## RECOMMENDATION

ADMINISTRATIVE DESIGN REVIEW

DCI # 3037538-LU  
12322 14th Ave NE  
Seattle, WA 98125

ITEMIZED RESPONSE TO EDG  
MUP CYCLE 2

SITE PLAN

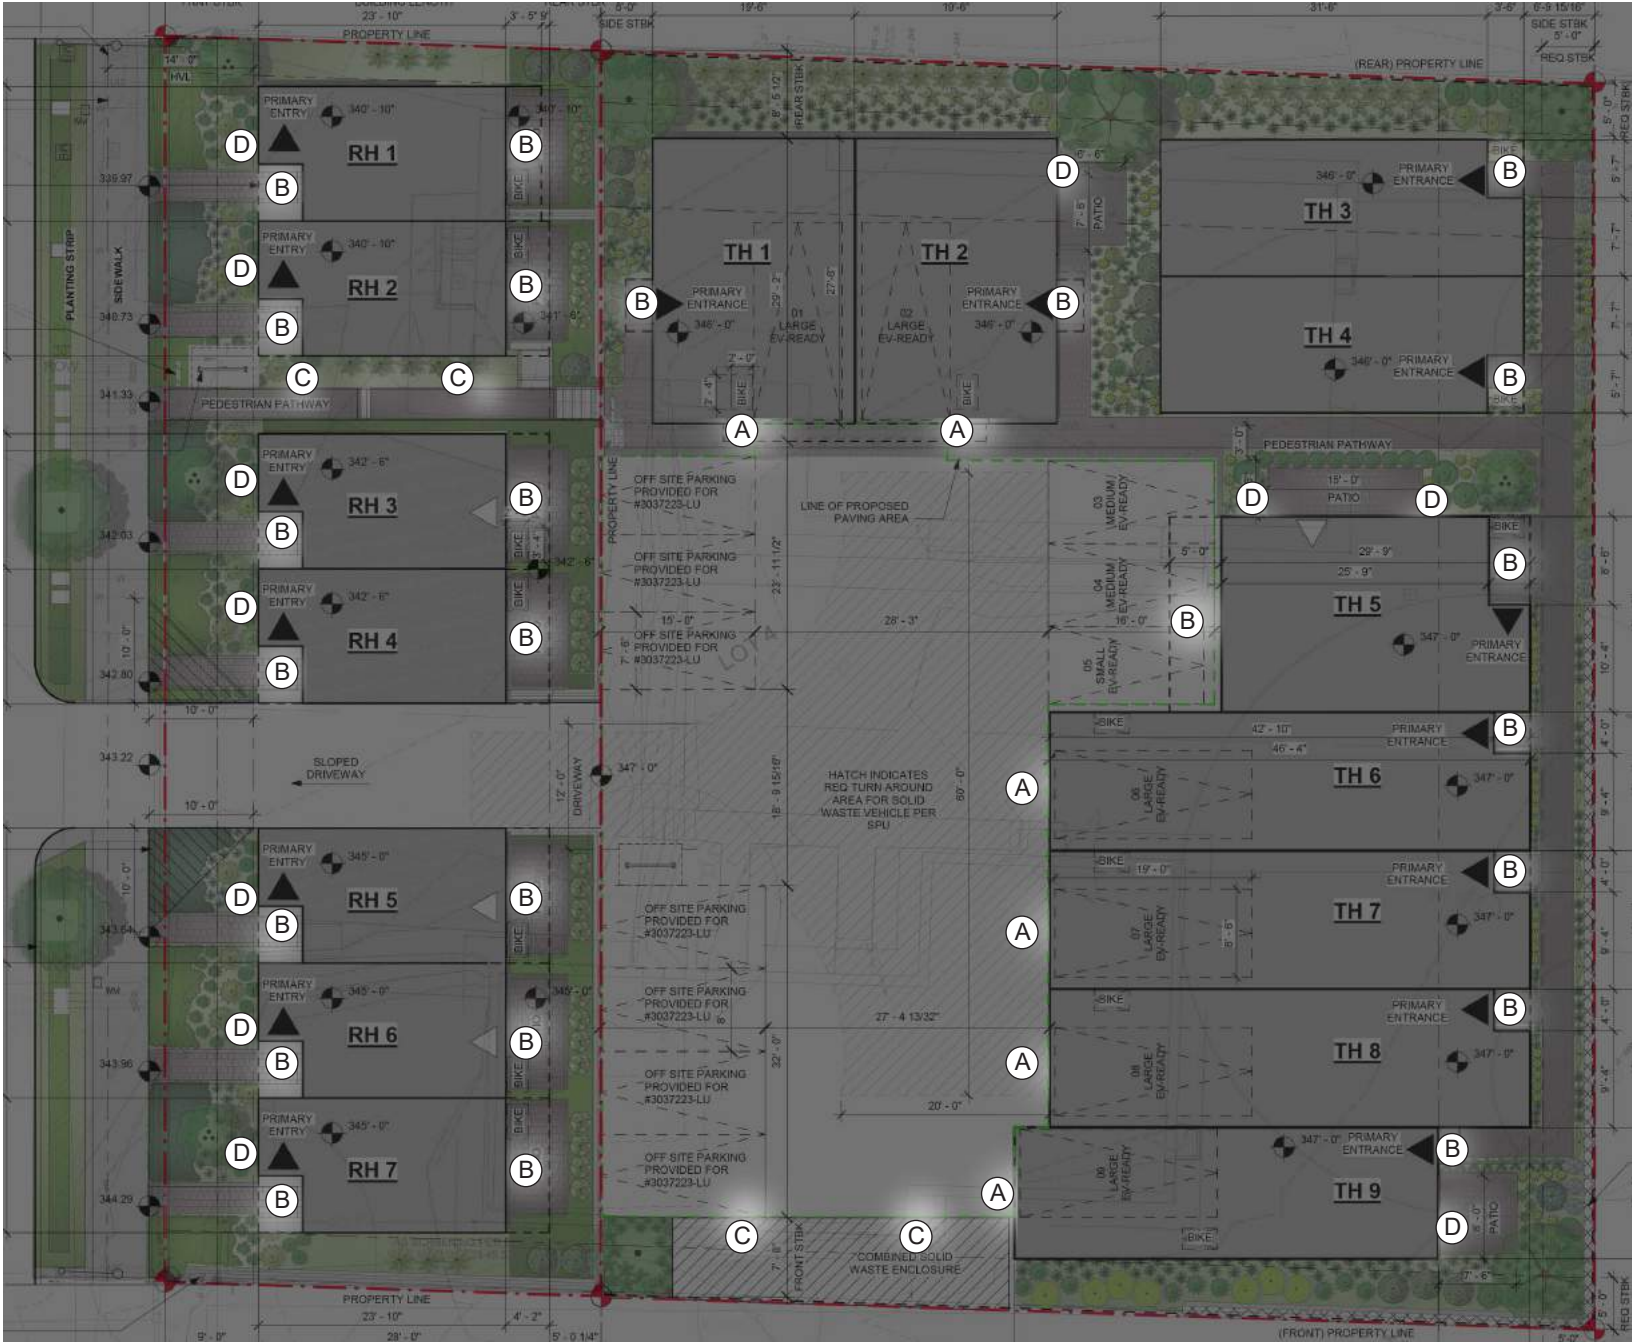
EDG Guidance 2.c. states, “Reinforce the overall architectural and open space design concepts through the selection of landscape materials. Hardscaped areas are an opportunity to add texture and pattern. Include in the Recommendation packet details describing the pedestrian walkway and parking surfaces. (DC4-D Exterior Elements and Finishes, DC4-D Trees, Landscape, and Hardscape Materials)”

EDG Guidance (2.a.) states, “The setback between the building and sidewalk provides opportunity for a lush landscaping to provide for unit privacy and visual interest at the public realm. Develop the residential entry sequence, considering the transition from public to private space. (PL3-A Entries, DC4-D Trees, Landscape, and Hardscape Materials)” Include in the Recommendation packet graphics to clearly illustrate this entry sequence. How has plant selection aided in the transition from public to private space? Is layering of landscaping proposed to provide dimension in height?

We propose two different patterns and colors to further differentiate the hardscape across the site. Creating a safe pedestrian access and bringing interest through the use of distinctive and durable paving materials. See landscape sheets for material spec.

The project uses landscape to reinforce the overall architectural and open space design concepts. At the street frontage, it is layered to serve as a transition space, from public to private. The landscape also aids on the privacy of the rear yards proposed on the rowhouses, creating a buffer of wood fence and landscape between the parking area and rear private amenity. The landscape design proposed helps define spaces with elements such as trees, hardscape pattern, location, and natural screening throughout the site, with attention brought to patio spaces and adjacent existing buildings. Please see full landscaped details and specs on landscape plans and 3D perspectives for overall proposal.

**SITE SCREANING**

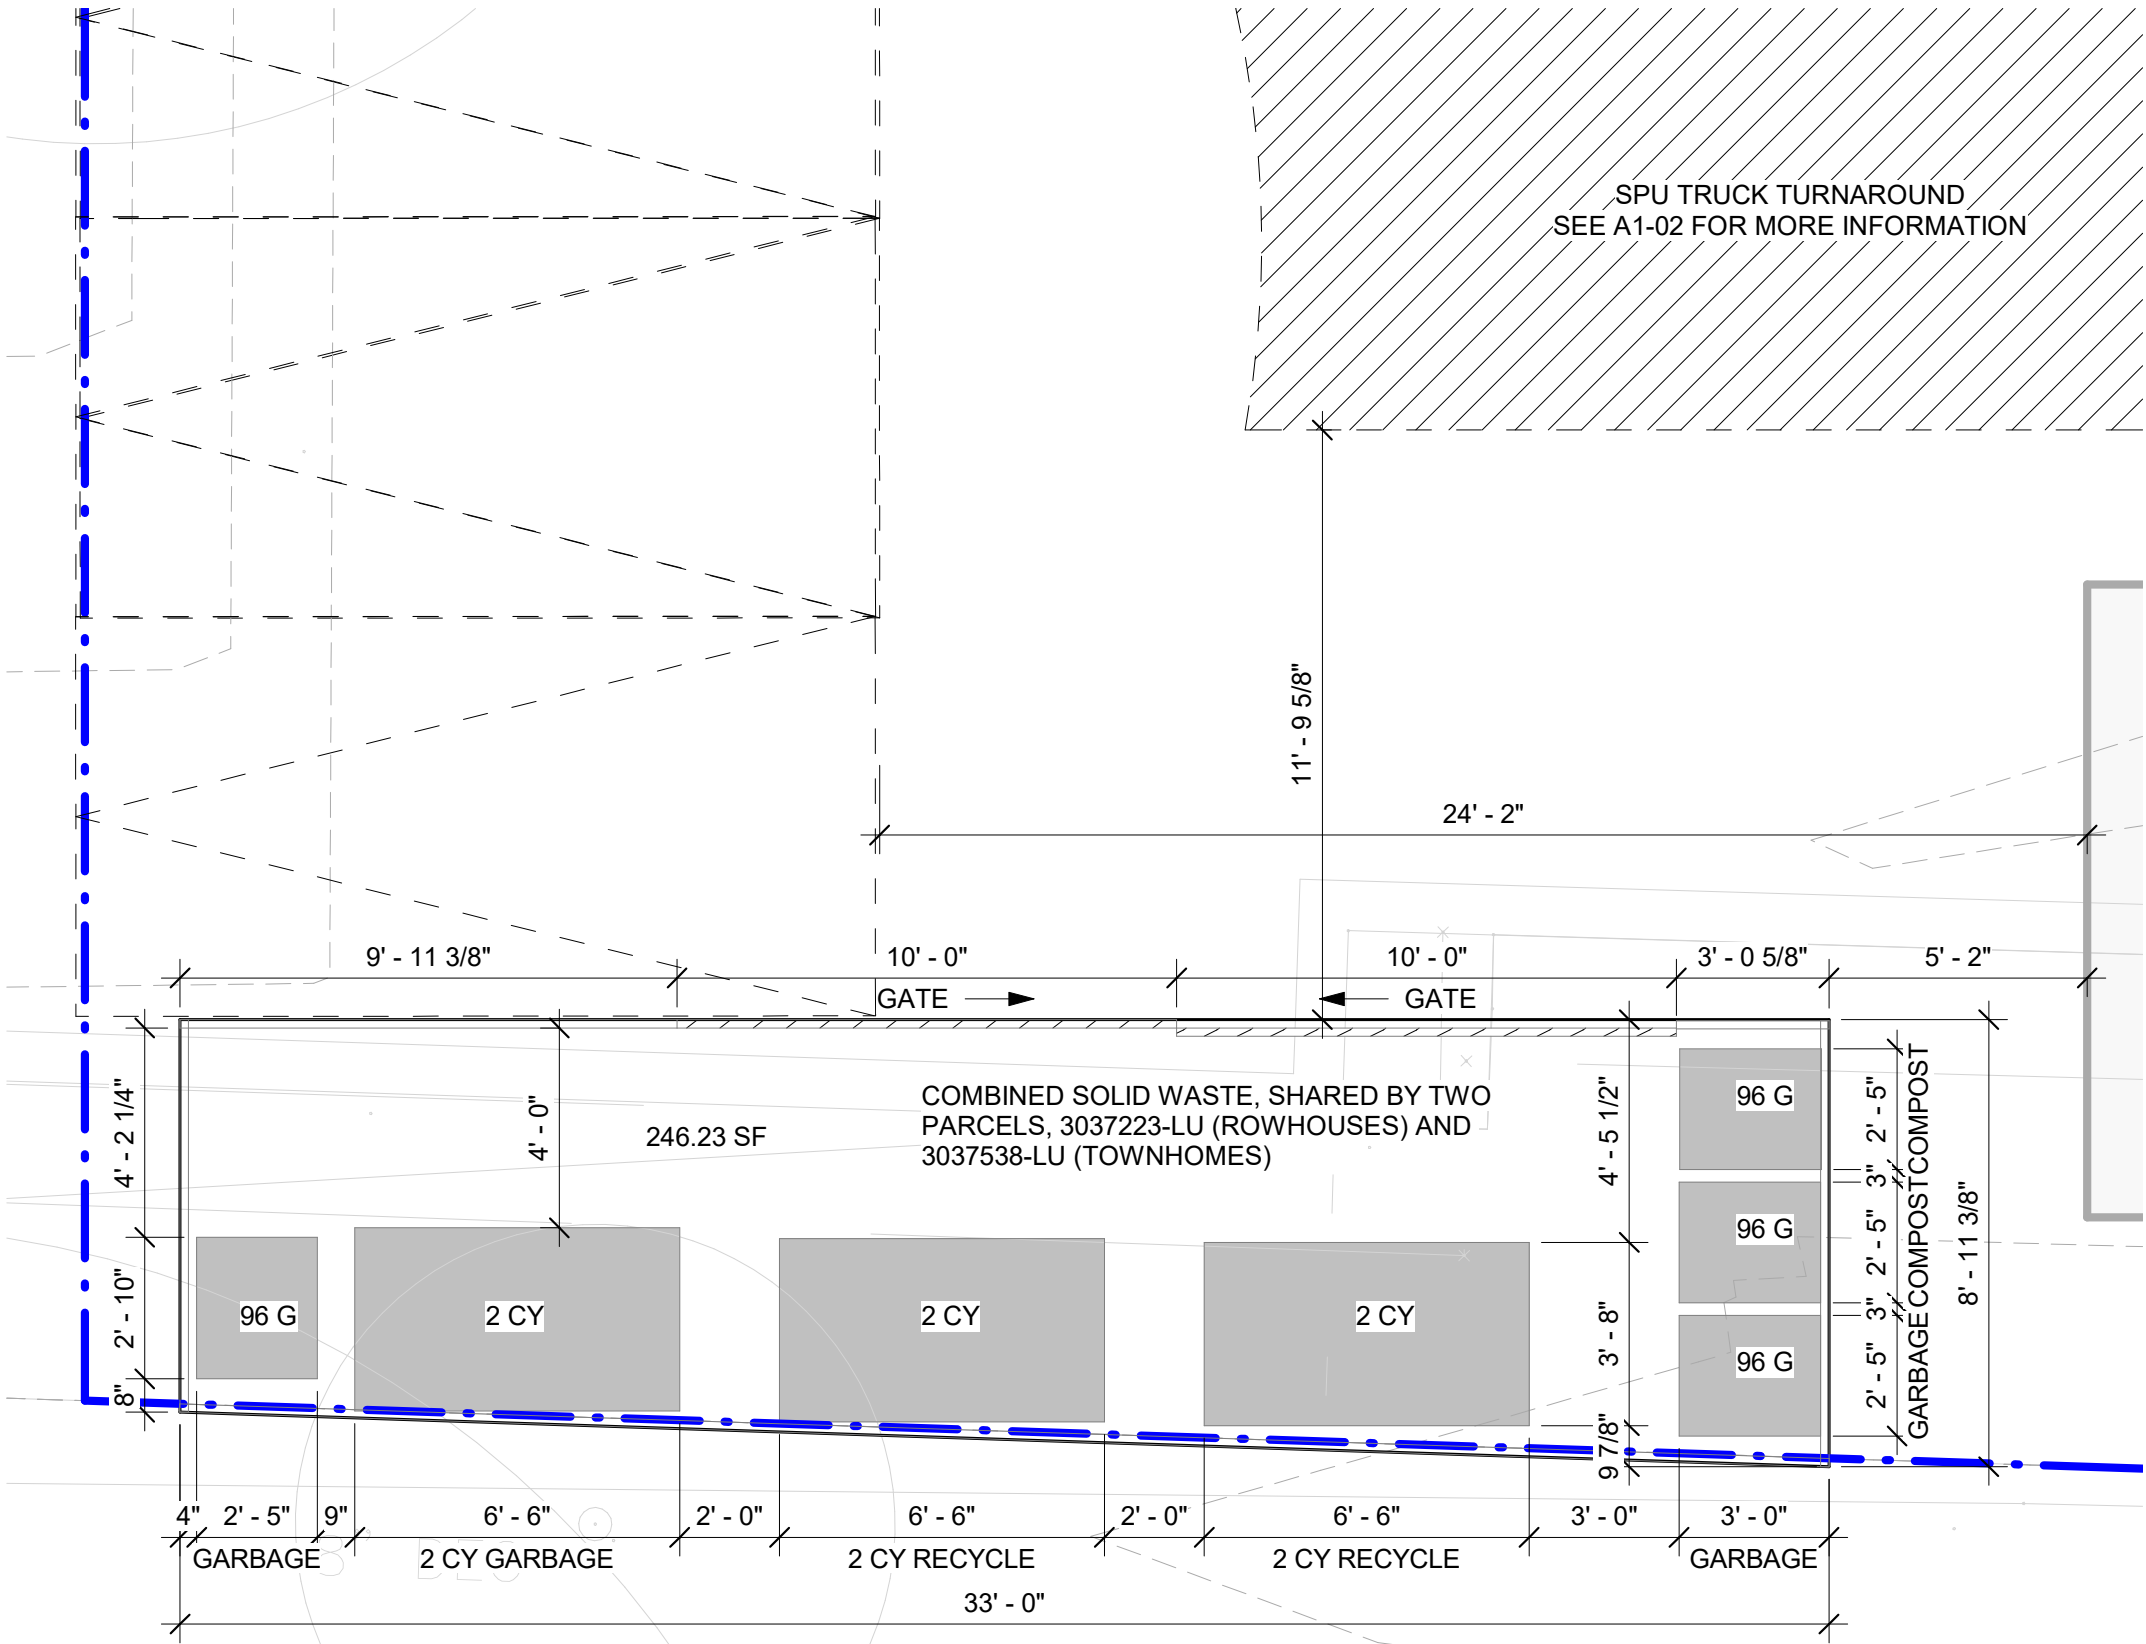
EDG Guidance 1.c. states, “The site is located adjacent to single-family development to the south and responds by locating a majority of the massing to the north and providing screening for surface parking. Respect adjacent properties through design to minimize disrupting the privacy and outdoor activities of residents in adjacent buildings. Staff recommends careful attention to the privacy of the abutting residential uses. Describe those design strategies utilized to minimize privacy impacts. (CS2-D.5 Respect for Adjacent Sites)”

The location of the majority of massing to the north has been maintained. In addition to locating the massing away from the southern neighbor, we propose a wood fence and a landscaped setback to help with glare and privacy between the single family and multifamily zones. The primary glazing for the townhomes and rowhouses have been proposed facing the autocourt and the right of way. Maintaining the privacy between our project and our adjacent neighbors. The glazing facing the north and south utilizes high silled windows and is proposed to minimize any adjacent existing window placement. The southern single family residences are setback over 60 feet from our shared property line and have existing vegetation on there property creating an existing landscape buffer between parcels.

Due to the existing topography, we propose the rowhouses to step down to better meet the sidewalk. This condition creates a sunken rear yard, that allows sunlight while still maintaining privacy from the common areas. Along the retaining wall we propose a wood slat fencing in combination with a planter, creating the opportunity for tall landscape that further shields the rear yards from headlights and creates a more functional place. In between units we propose a semi-transparent privacy screen, to match the soffits and siding materials, and provide more interest and privacy to the private amenity spaces. (CS1.C.2, PL2.C.3)

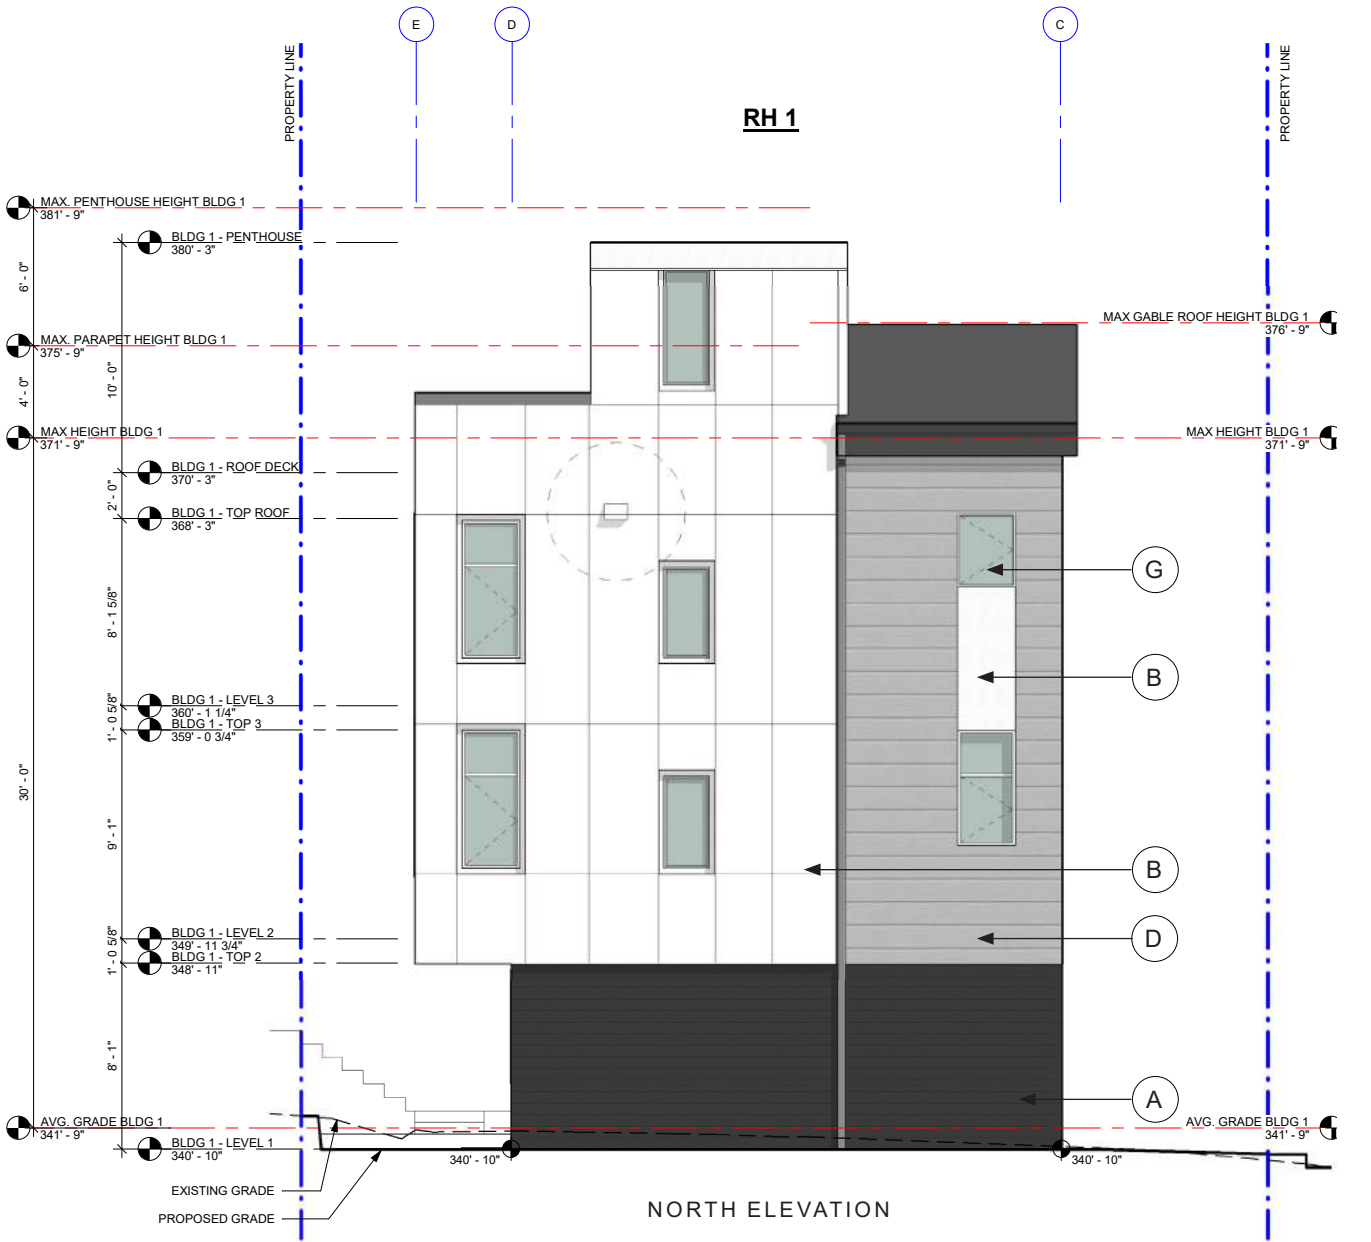
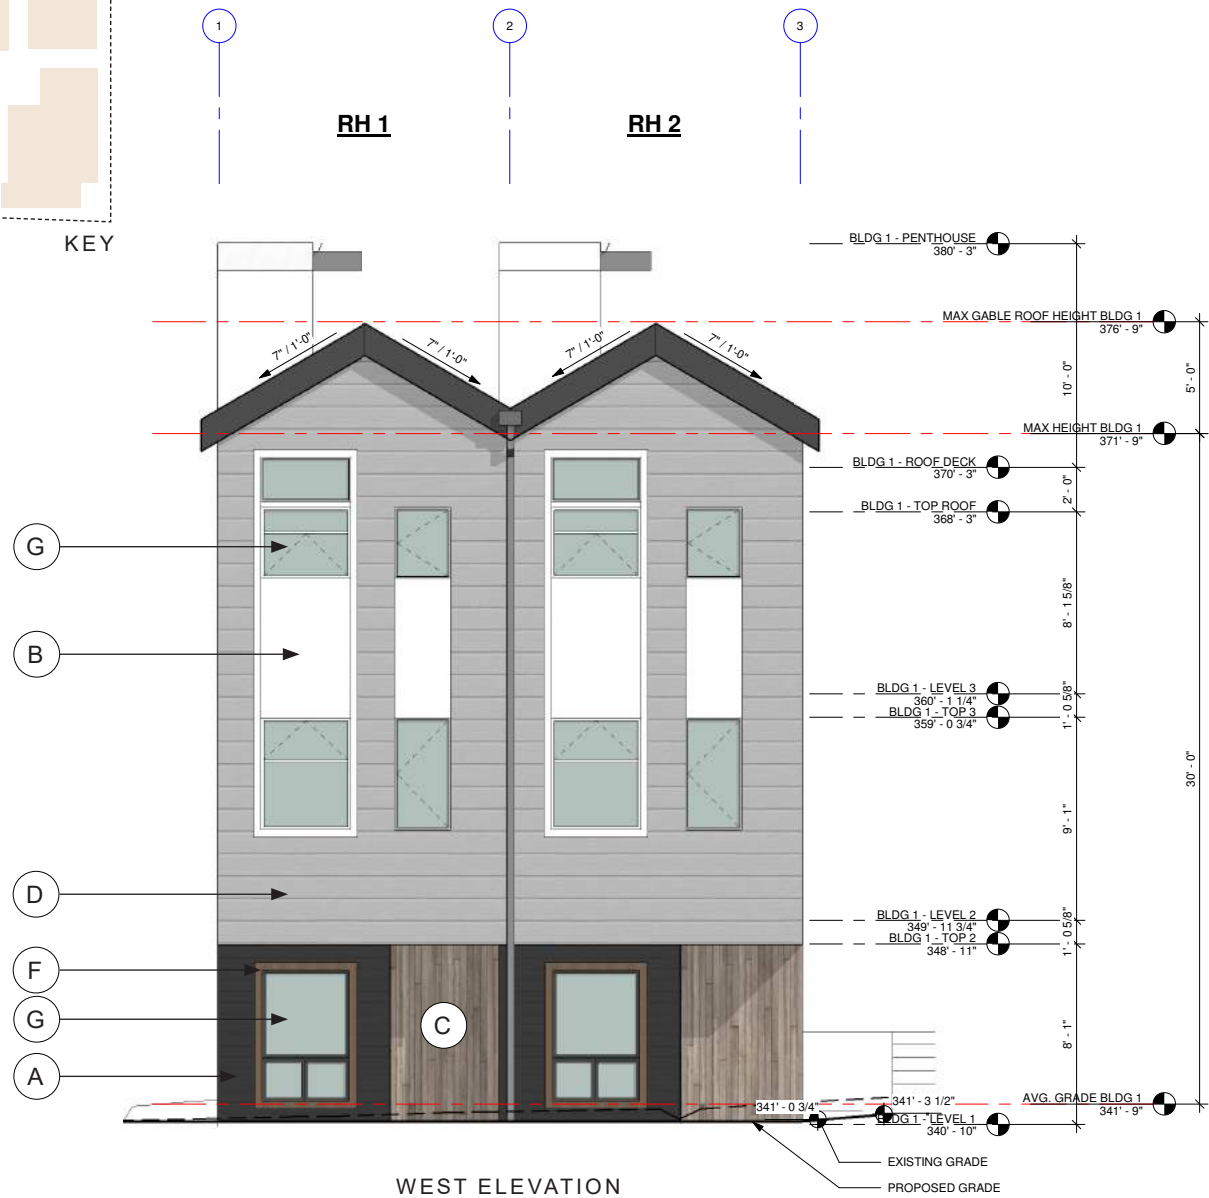
White vinyl windows are proposed at the first floor, in a façade clad in dark gray fiber cement siding. Where black vinyl windows considered for this portion of the facades? Include your study of this condition in the Recommendation packet.

EDG Guidance 1.e. states, “Public comment recommended and staff agrees that the project fit into the existing context of wood exteriors and shingle roofs. Shed roof lines are proposed along the street facing units to reduce perceived bulk of the stair towers and respond to the existing residential scale of the neighborhood and is supported. To further mitigate perceived height, bulk, and scale, explore parapets that are transparent or less opaque in order. (CS2-D Height, Bulk, and Scale)” Include your study in the Recommendation packet

*After studying black windows at the base of the project, we agree that it better fits the design, and adds to the definition of the ground level experience. Please see all windows at base of project proposed as black.*

*Gable roof lines have been maintained on street frontage, following the scale of the neighbors to the north. Please see investigation of open rail at the roof level on this page. Since the bulk of the project is already located away from the single family zone, providing open rail minimally reduces the bulk on the south side. Looking at reduction of bulk towards the center of the site is disruptive to the simple massing proposed here. The open rail breaks up the facade in a busy pattern and disrupts the simple rhythm of the facade.*
